HGY/2026/1858 – 6A Grange Road, Highgate - BASEMENT CONDITIONS

3. Major Issues resulting from Engineering drawing

Photograph of No 6 side extension from No 8 showing the exposed concrete assumed erroneously to form part of the No 6 foundations

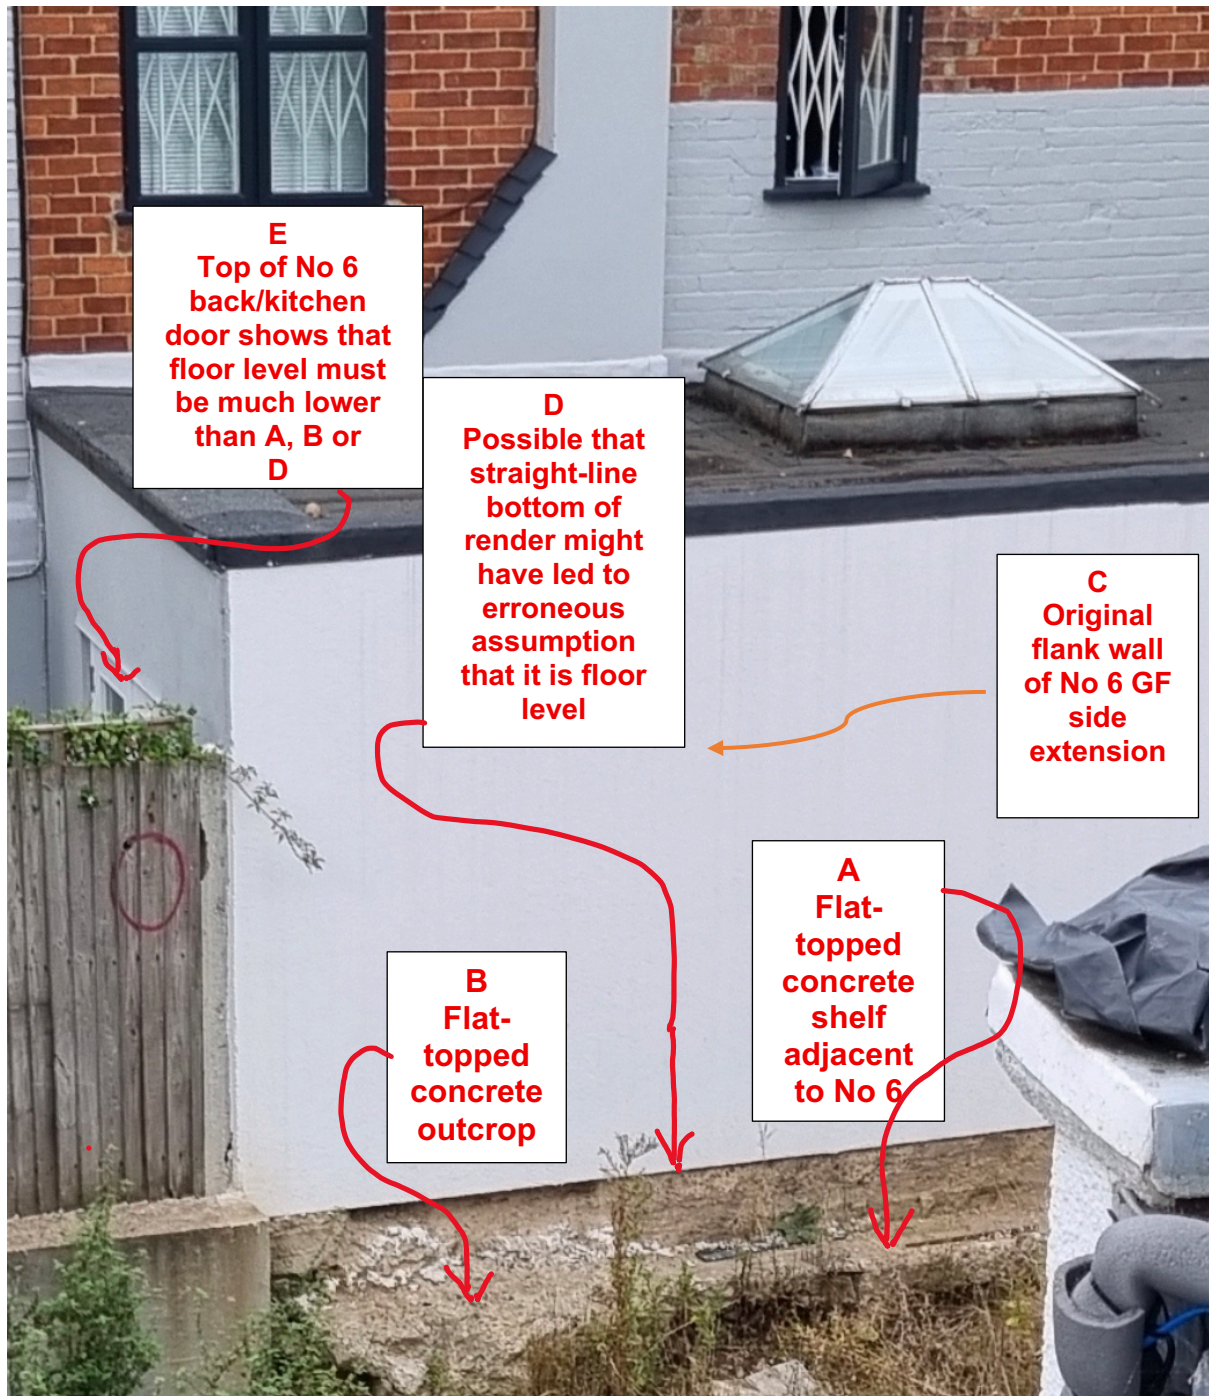
We can hazard a guess as to how all this this came about. In short, as a result of unlawful commencement of works under the 2018 scheme, and the removal of large amounts of earth from the site, various concrete structures were (and remain) exposed. It is possible that the Applicants' architect and engineers have assumed (erroneously) that the concrete shown near and against the No 6 boundary on the topographical survey at a level of about 111.47 aOD is part of the No 6 foundations. In fact that concrete is likely the foundations of (or remains of a raft for) the side extension of the 6A house demolished in 2019.

We attach as Annex A a photograph of the No 6 side extension (taken from No 8) which shows the concrete in question as well as giving a good indication as to the actual No 6 floor level.

Figure 4b: Foundation levels relative to No. 6 Grange Road

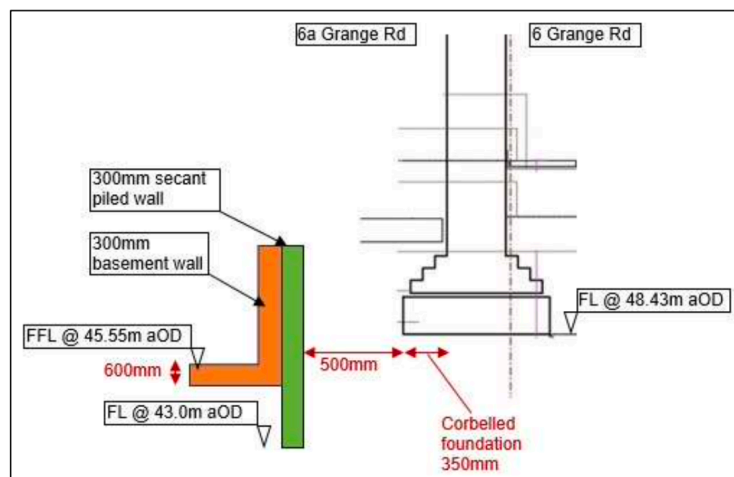
There was an engineering drawing for the No 6 side in Rev H of the BIA (Figure 4b in Appendix D (Ground Movement Calculation Sheets and WALLAP Analysis) in Volume 1) which showed the No 6 foundation level (base of the foundations) as 48.43 aOD (which equates to 110.90 aOD according to the revised topographical plan in the BIA Rev K) and a corbelled foundation extending 350mm (presumably 1000mm side to side). For ease of reference, the BIA Rev H drawing is included as Annex B.

It is now apparent that ***no proper investigation of the No 6 foundations has been conducted***, since why else would the drawing now use an "assumed" foundation reference? And further, that ***both of the No 6-side drawings*** referred to above (2630-HRW and Figure 4b in Appendix D in BIA Rev H) ***are materially wrong, as outlined below***.

Further, as the top of the No 6 foundations cannot be higher than 111.00 aOD, the **foundation level in Fig 4b of Rev H of the BIA of 110.90 aOD (just 10cm below) must also be wrong.**
